N6702A-02

Information Only Service Note

N6702A - Low-Profile Modular Power System

The Situation – Blue/white Front Panel LCD Display (below) has been obsoleted.

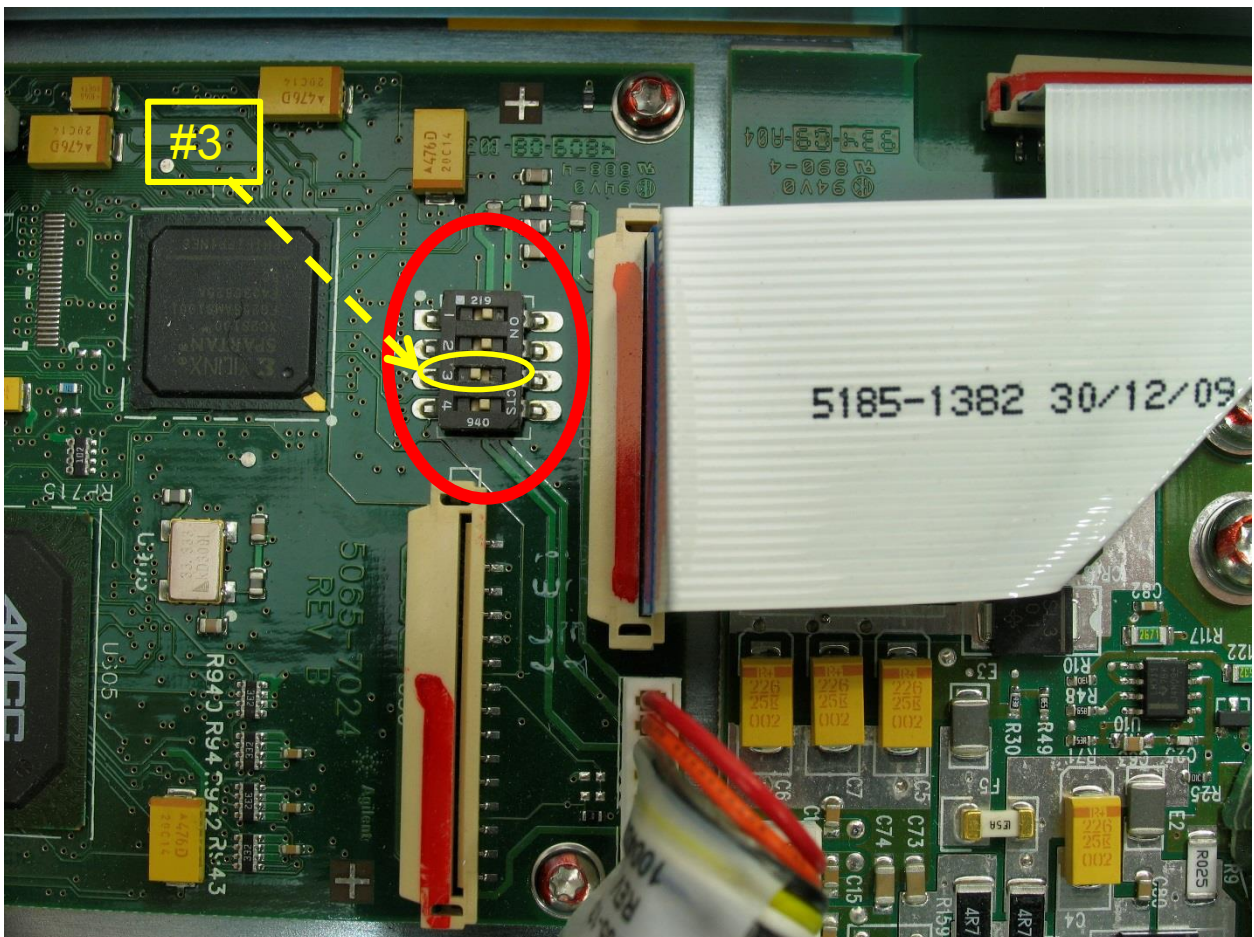
LCD (blue/white display assembly, p/n 2090-1031) has been discontinued by vendor. Replacement assembly (pictured later) is p/n 5067-6532 (amber in color). Difference in color is unfortunate, but cannot be altered.

1) New LCD display (5067-6532) is a mechanical & functional “drop-in” replacement for the original.

2) 4-pole dip switch on PPMC PCA must have pole #3 repositioned to “off” as shown below:

3) Instrument firmware must be version D.04.01 or newer for proper operation of this display.
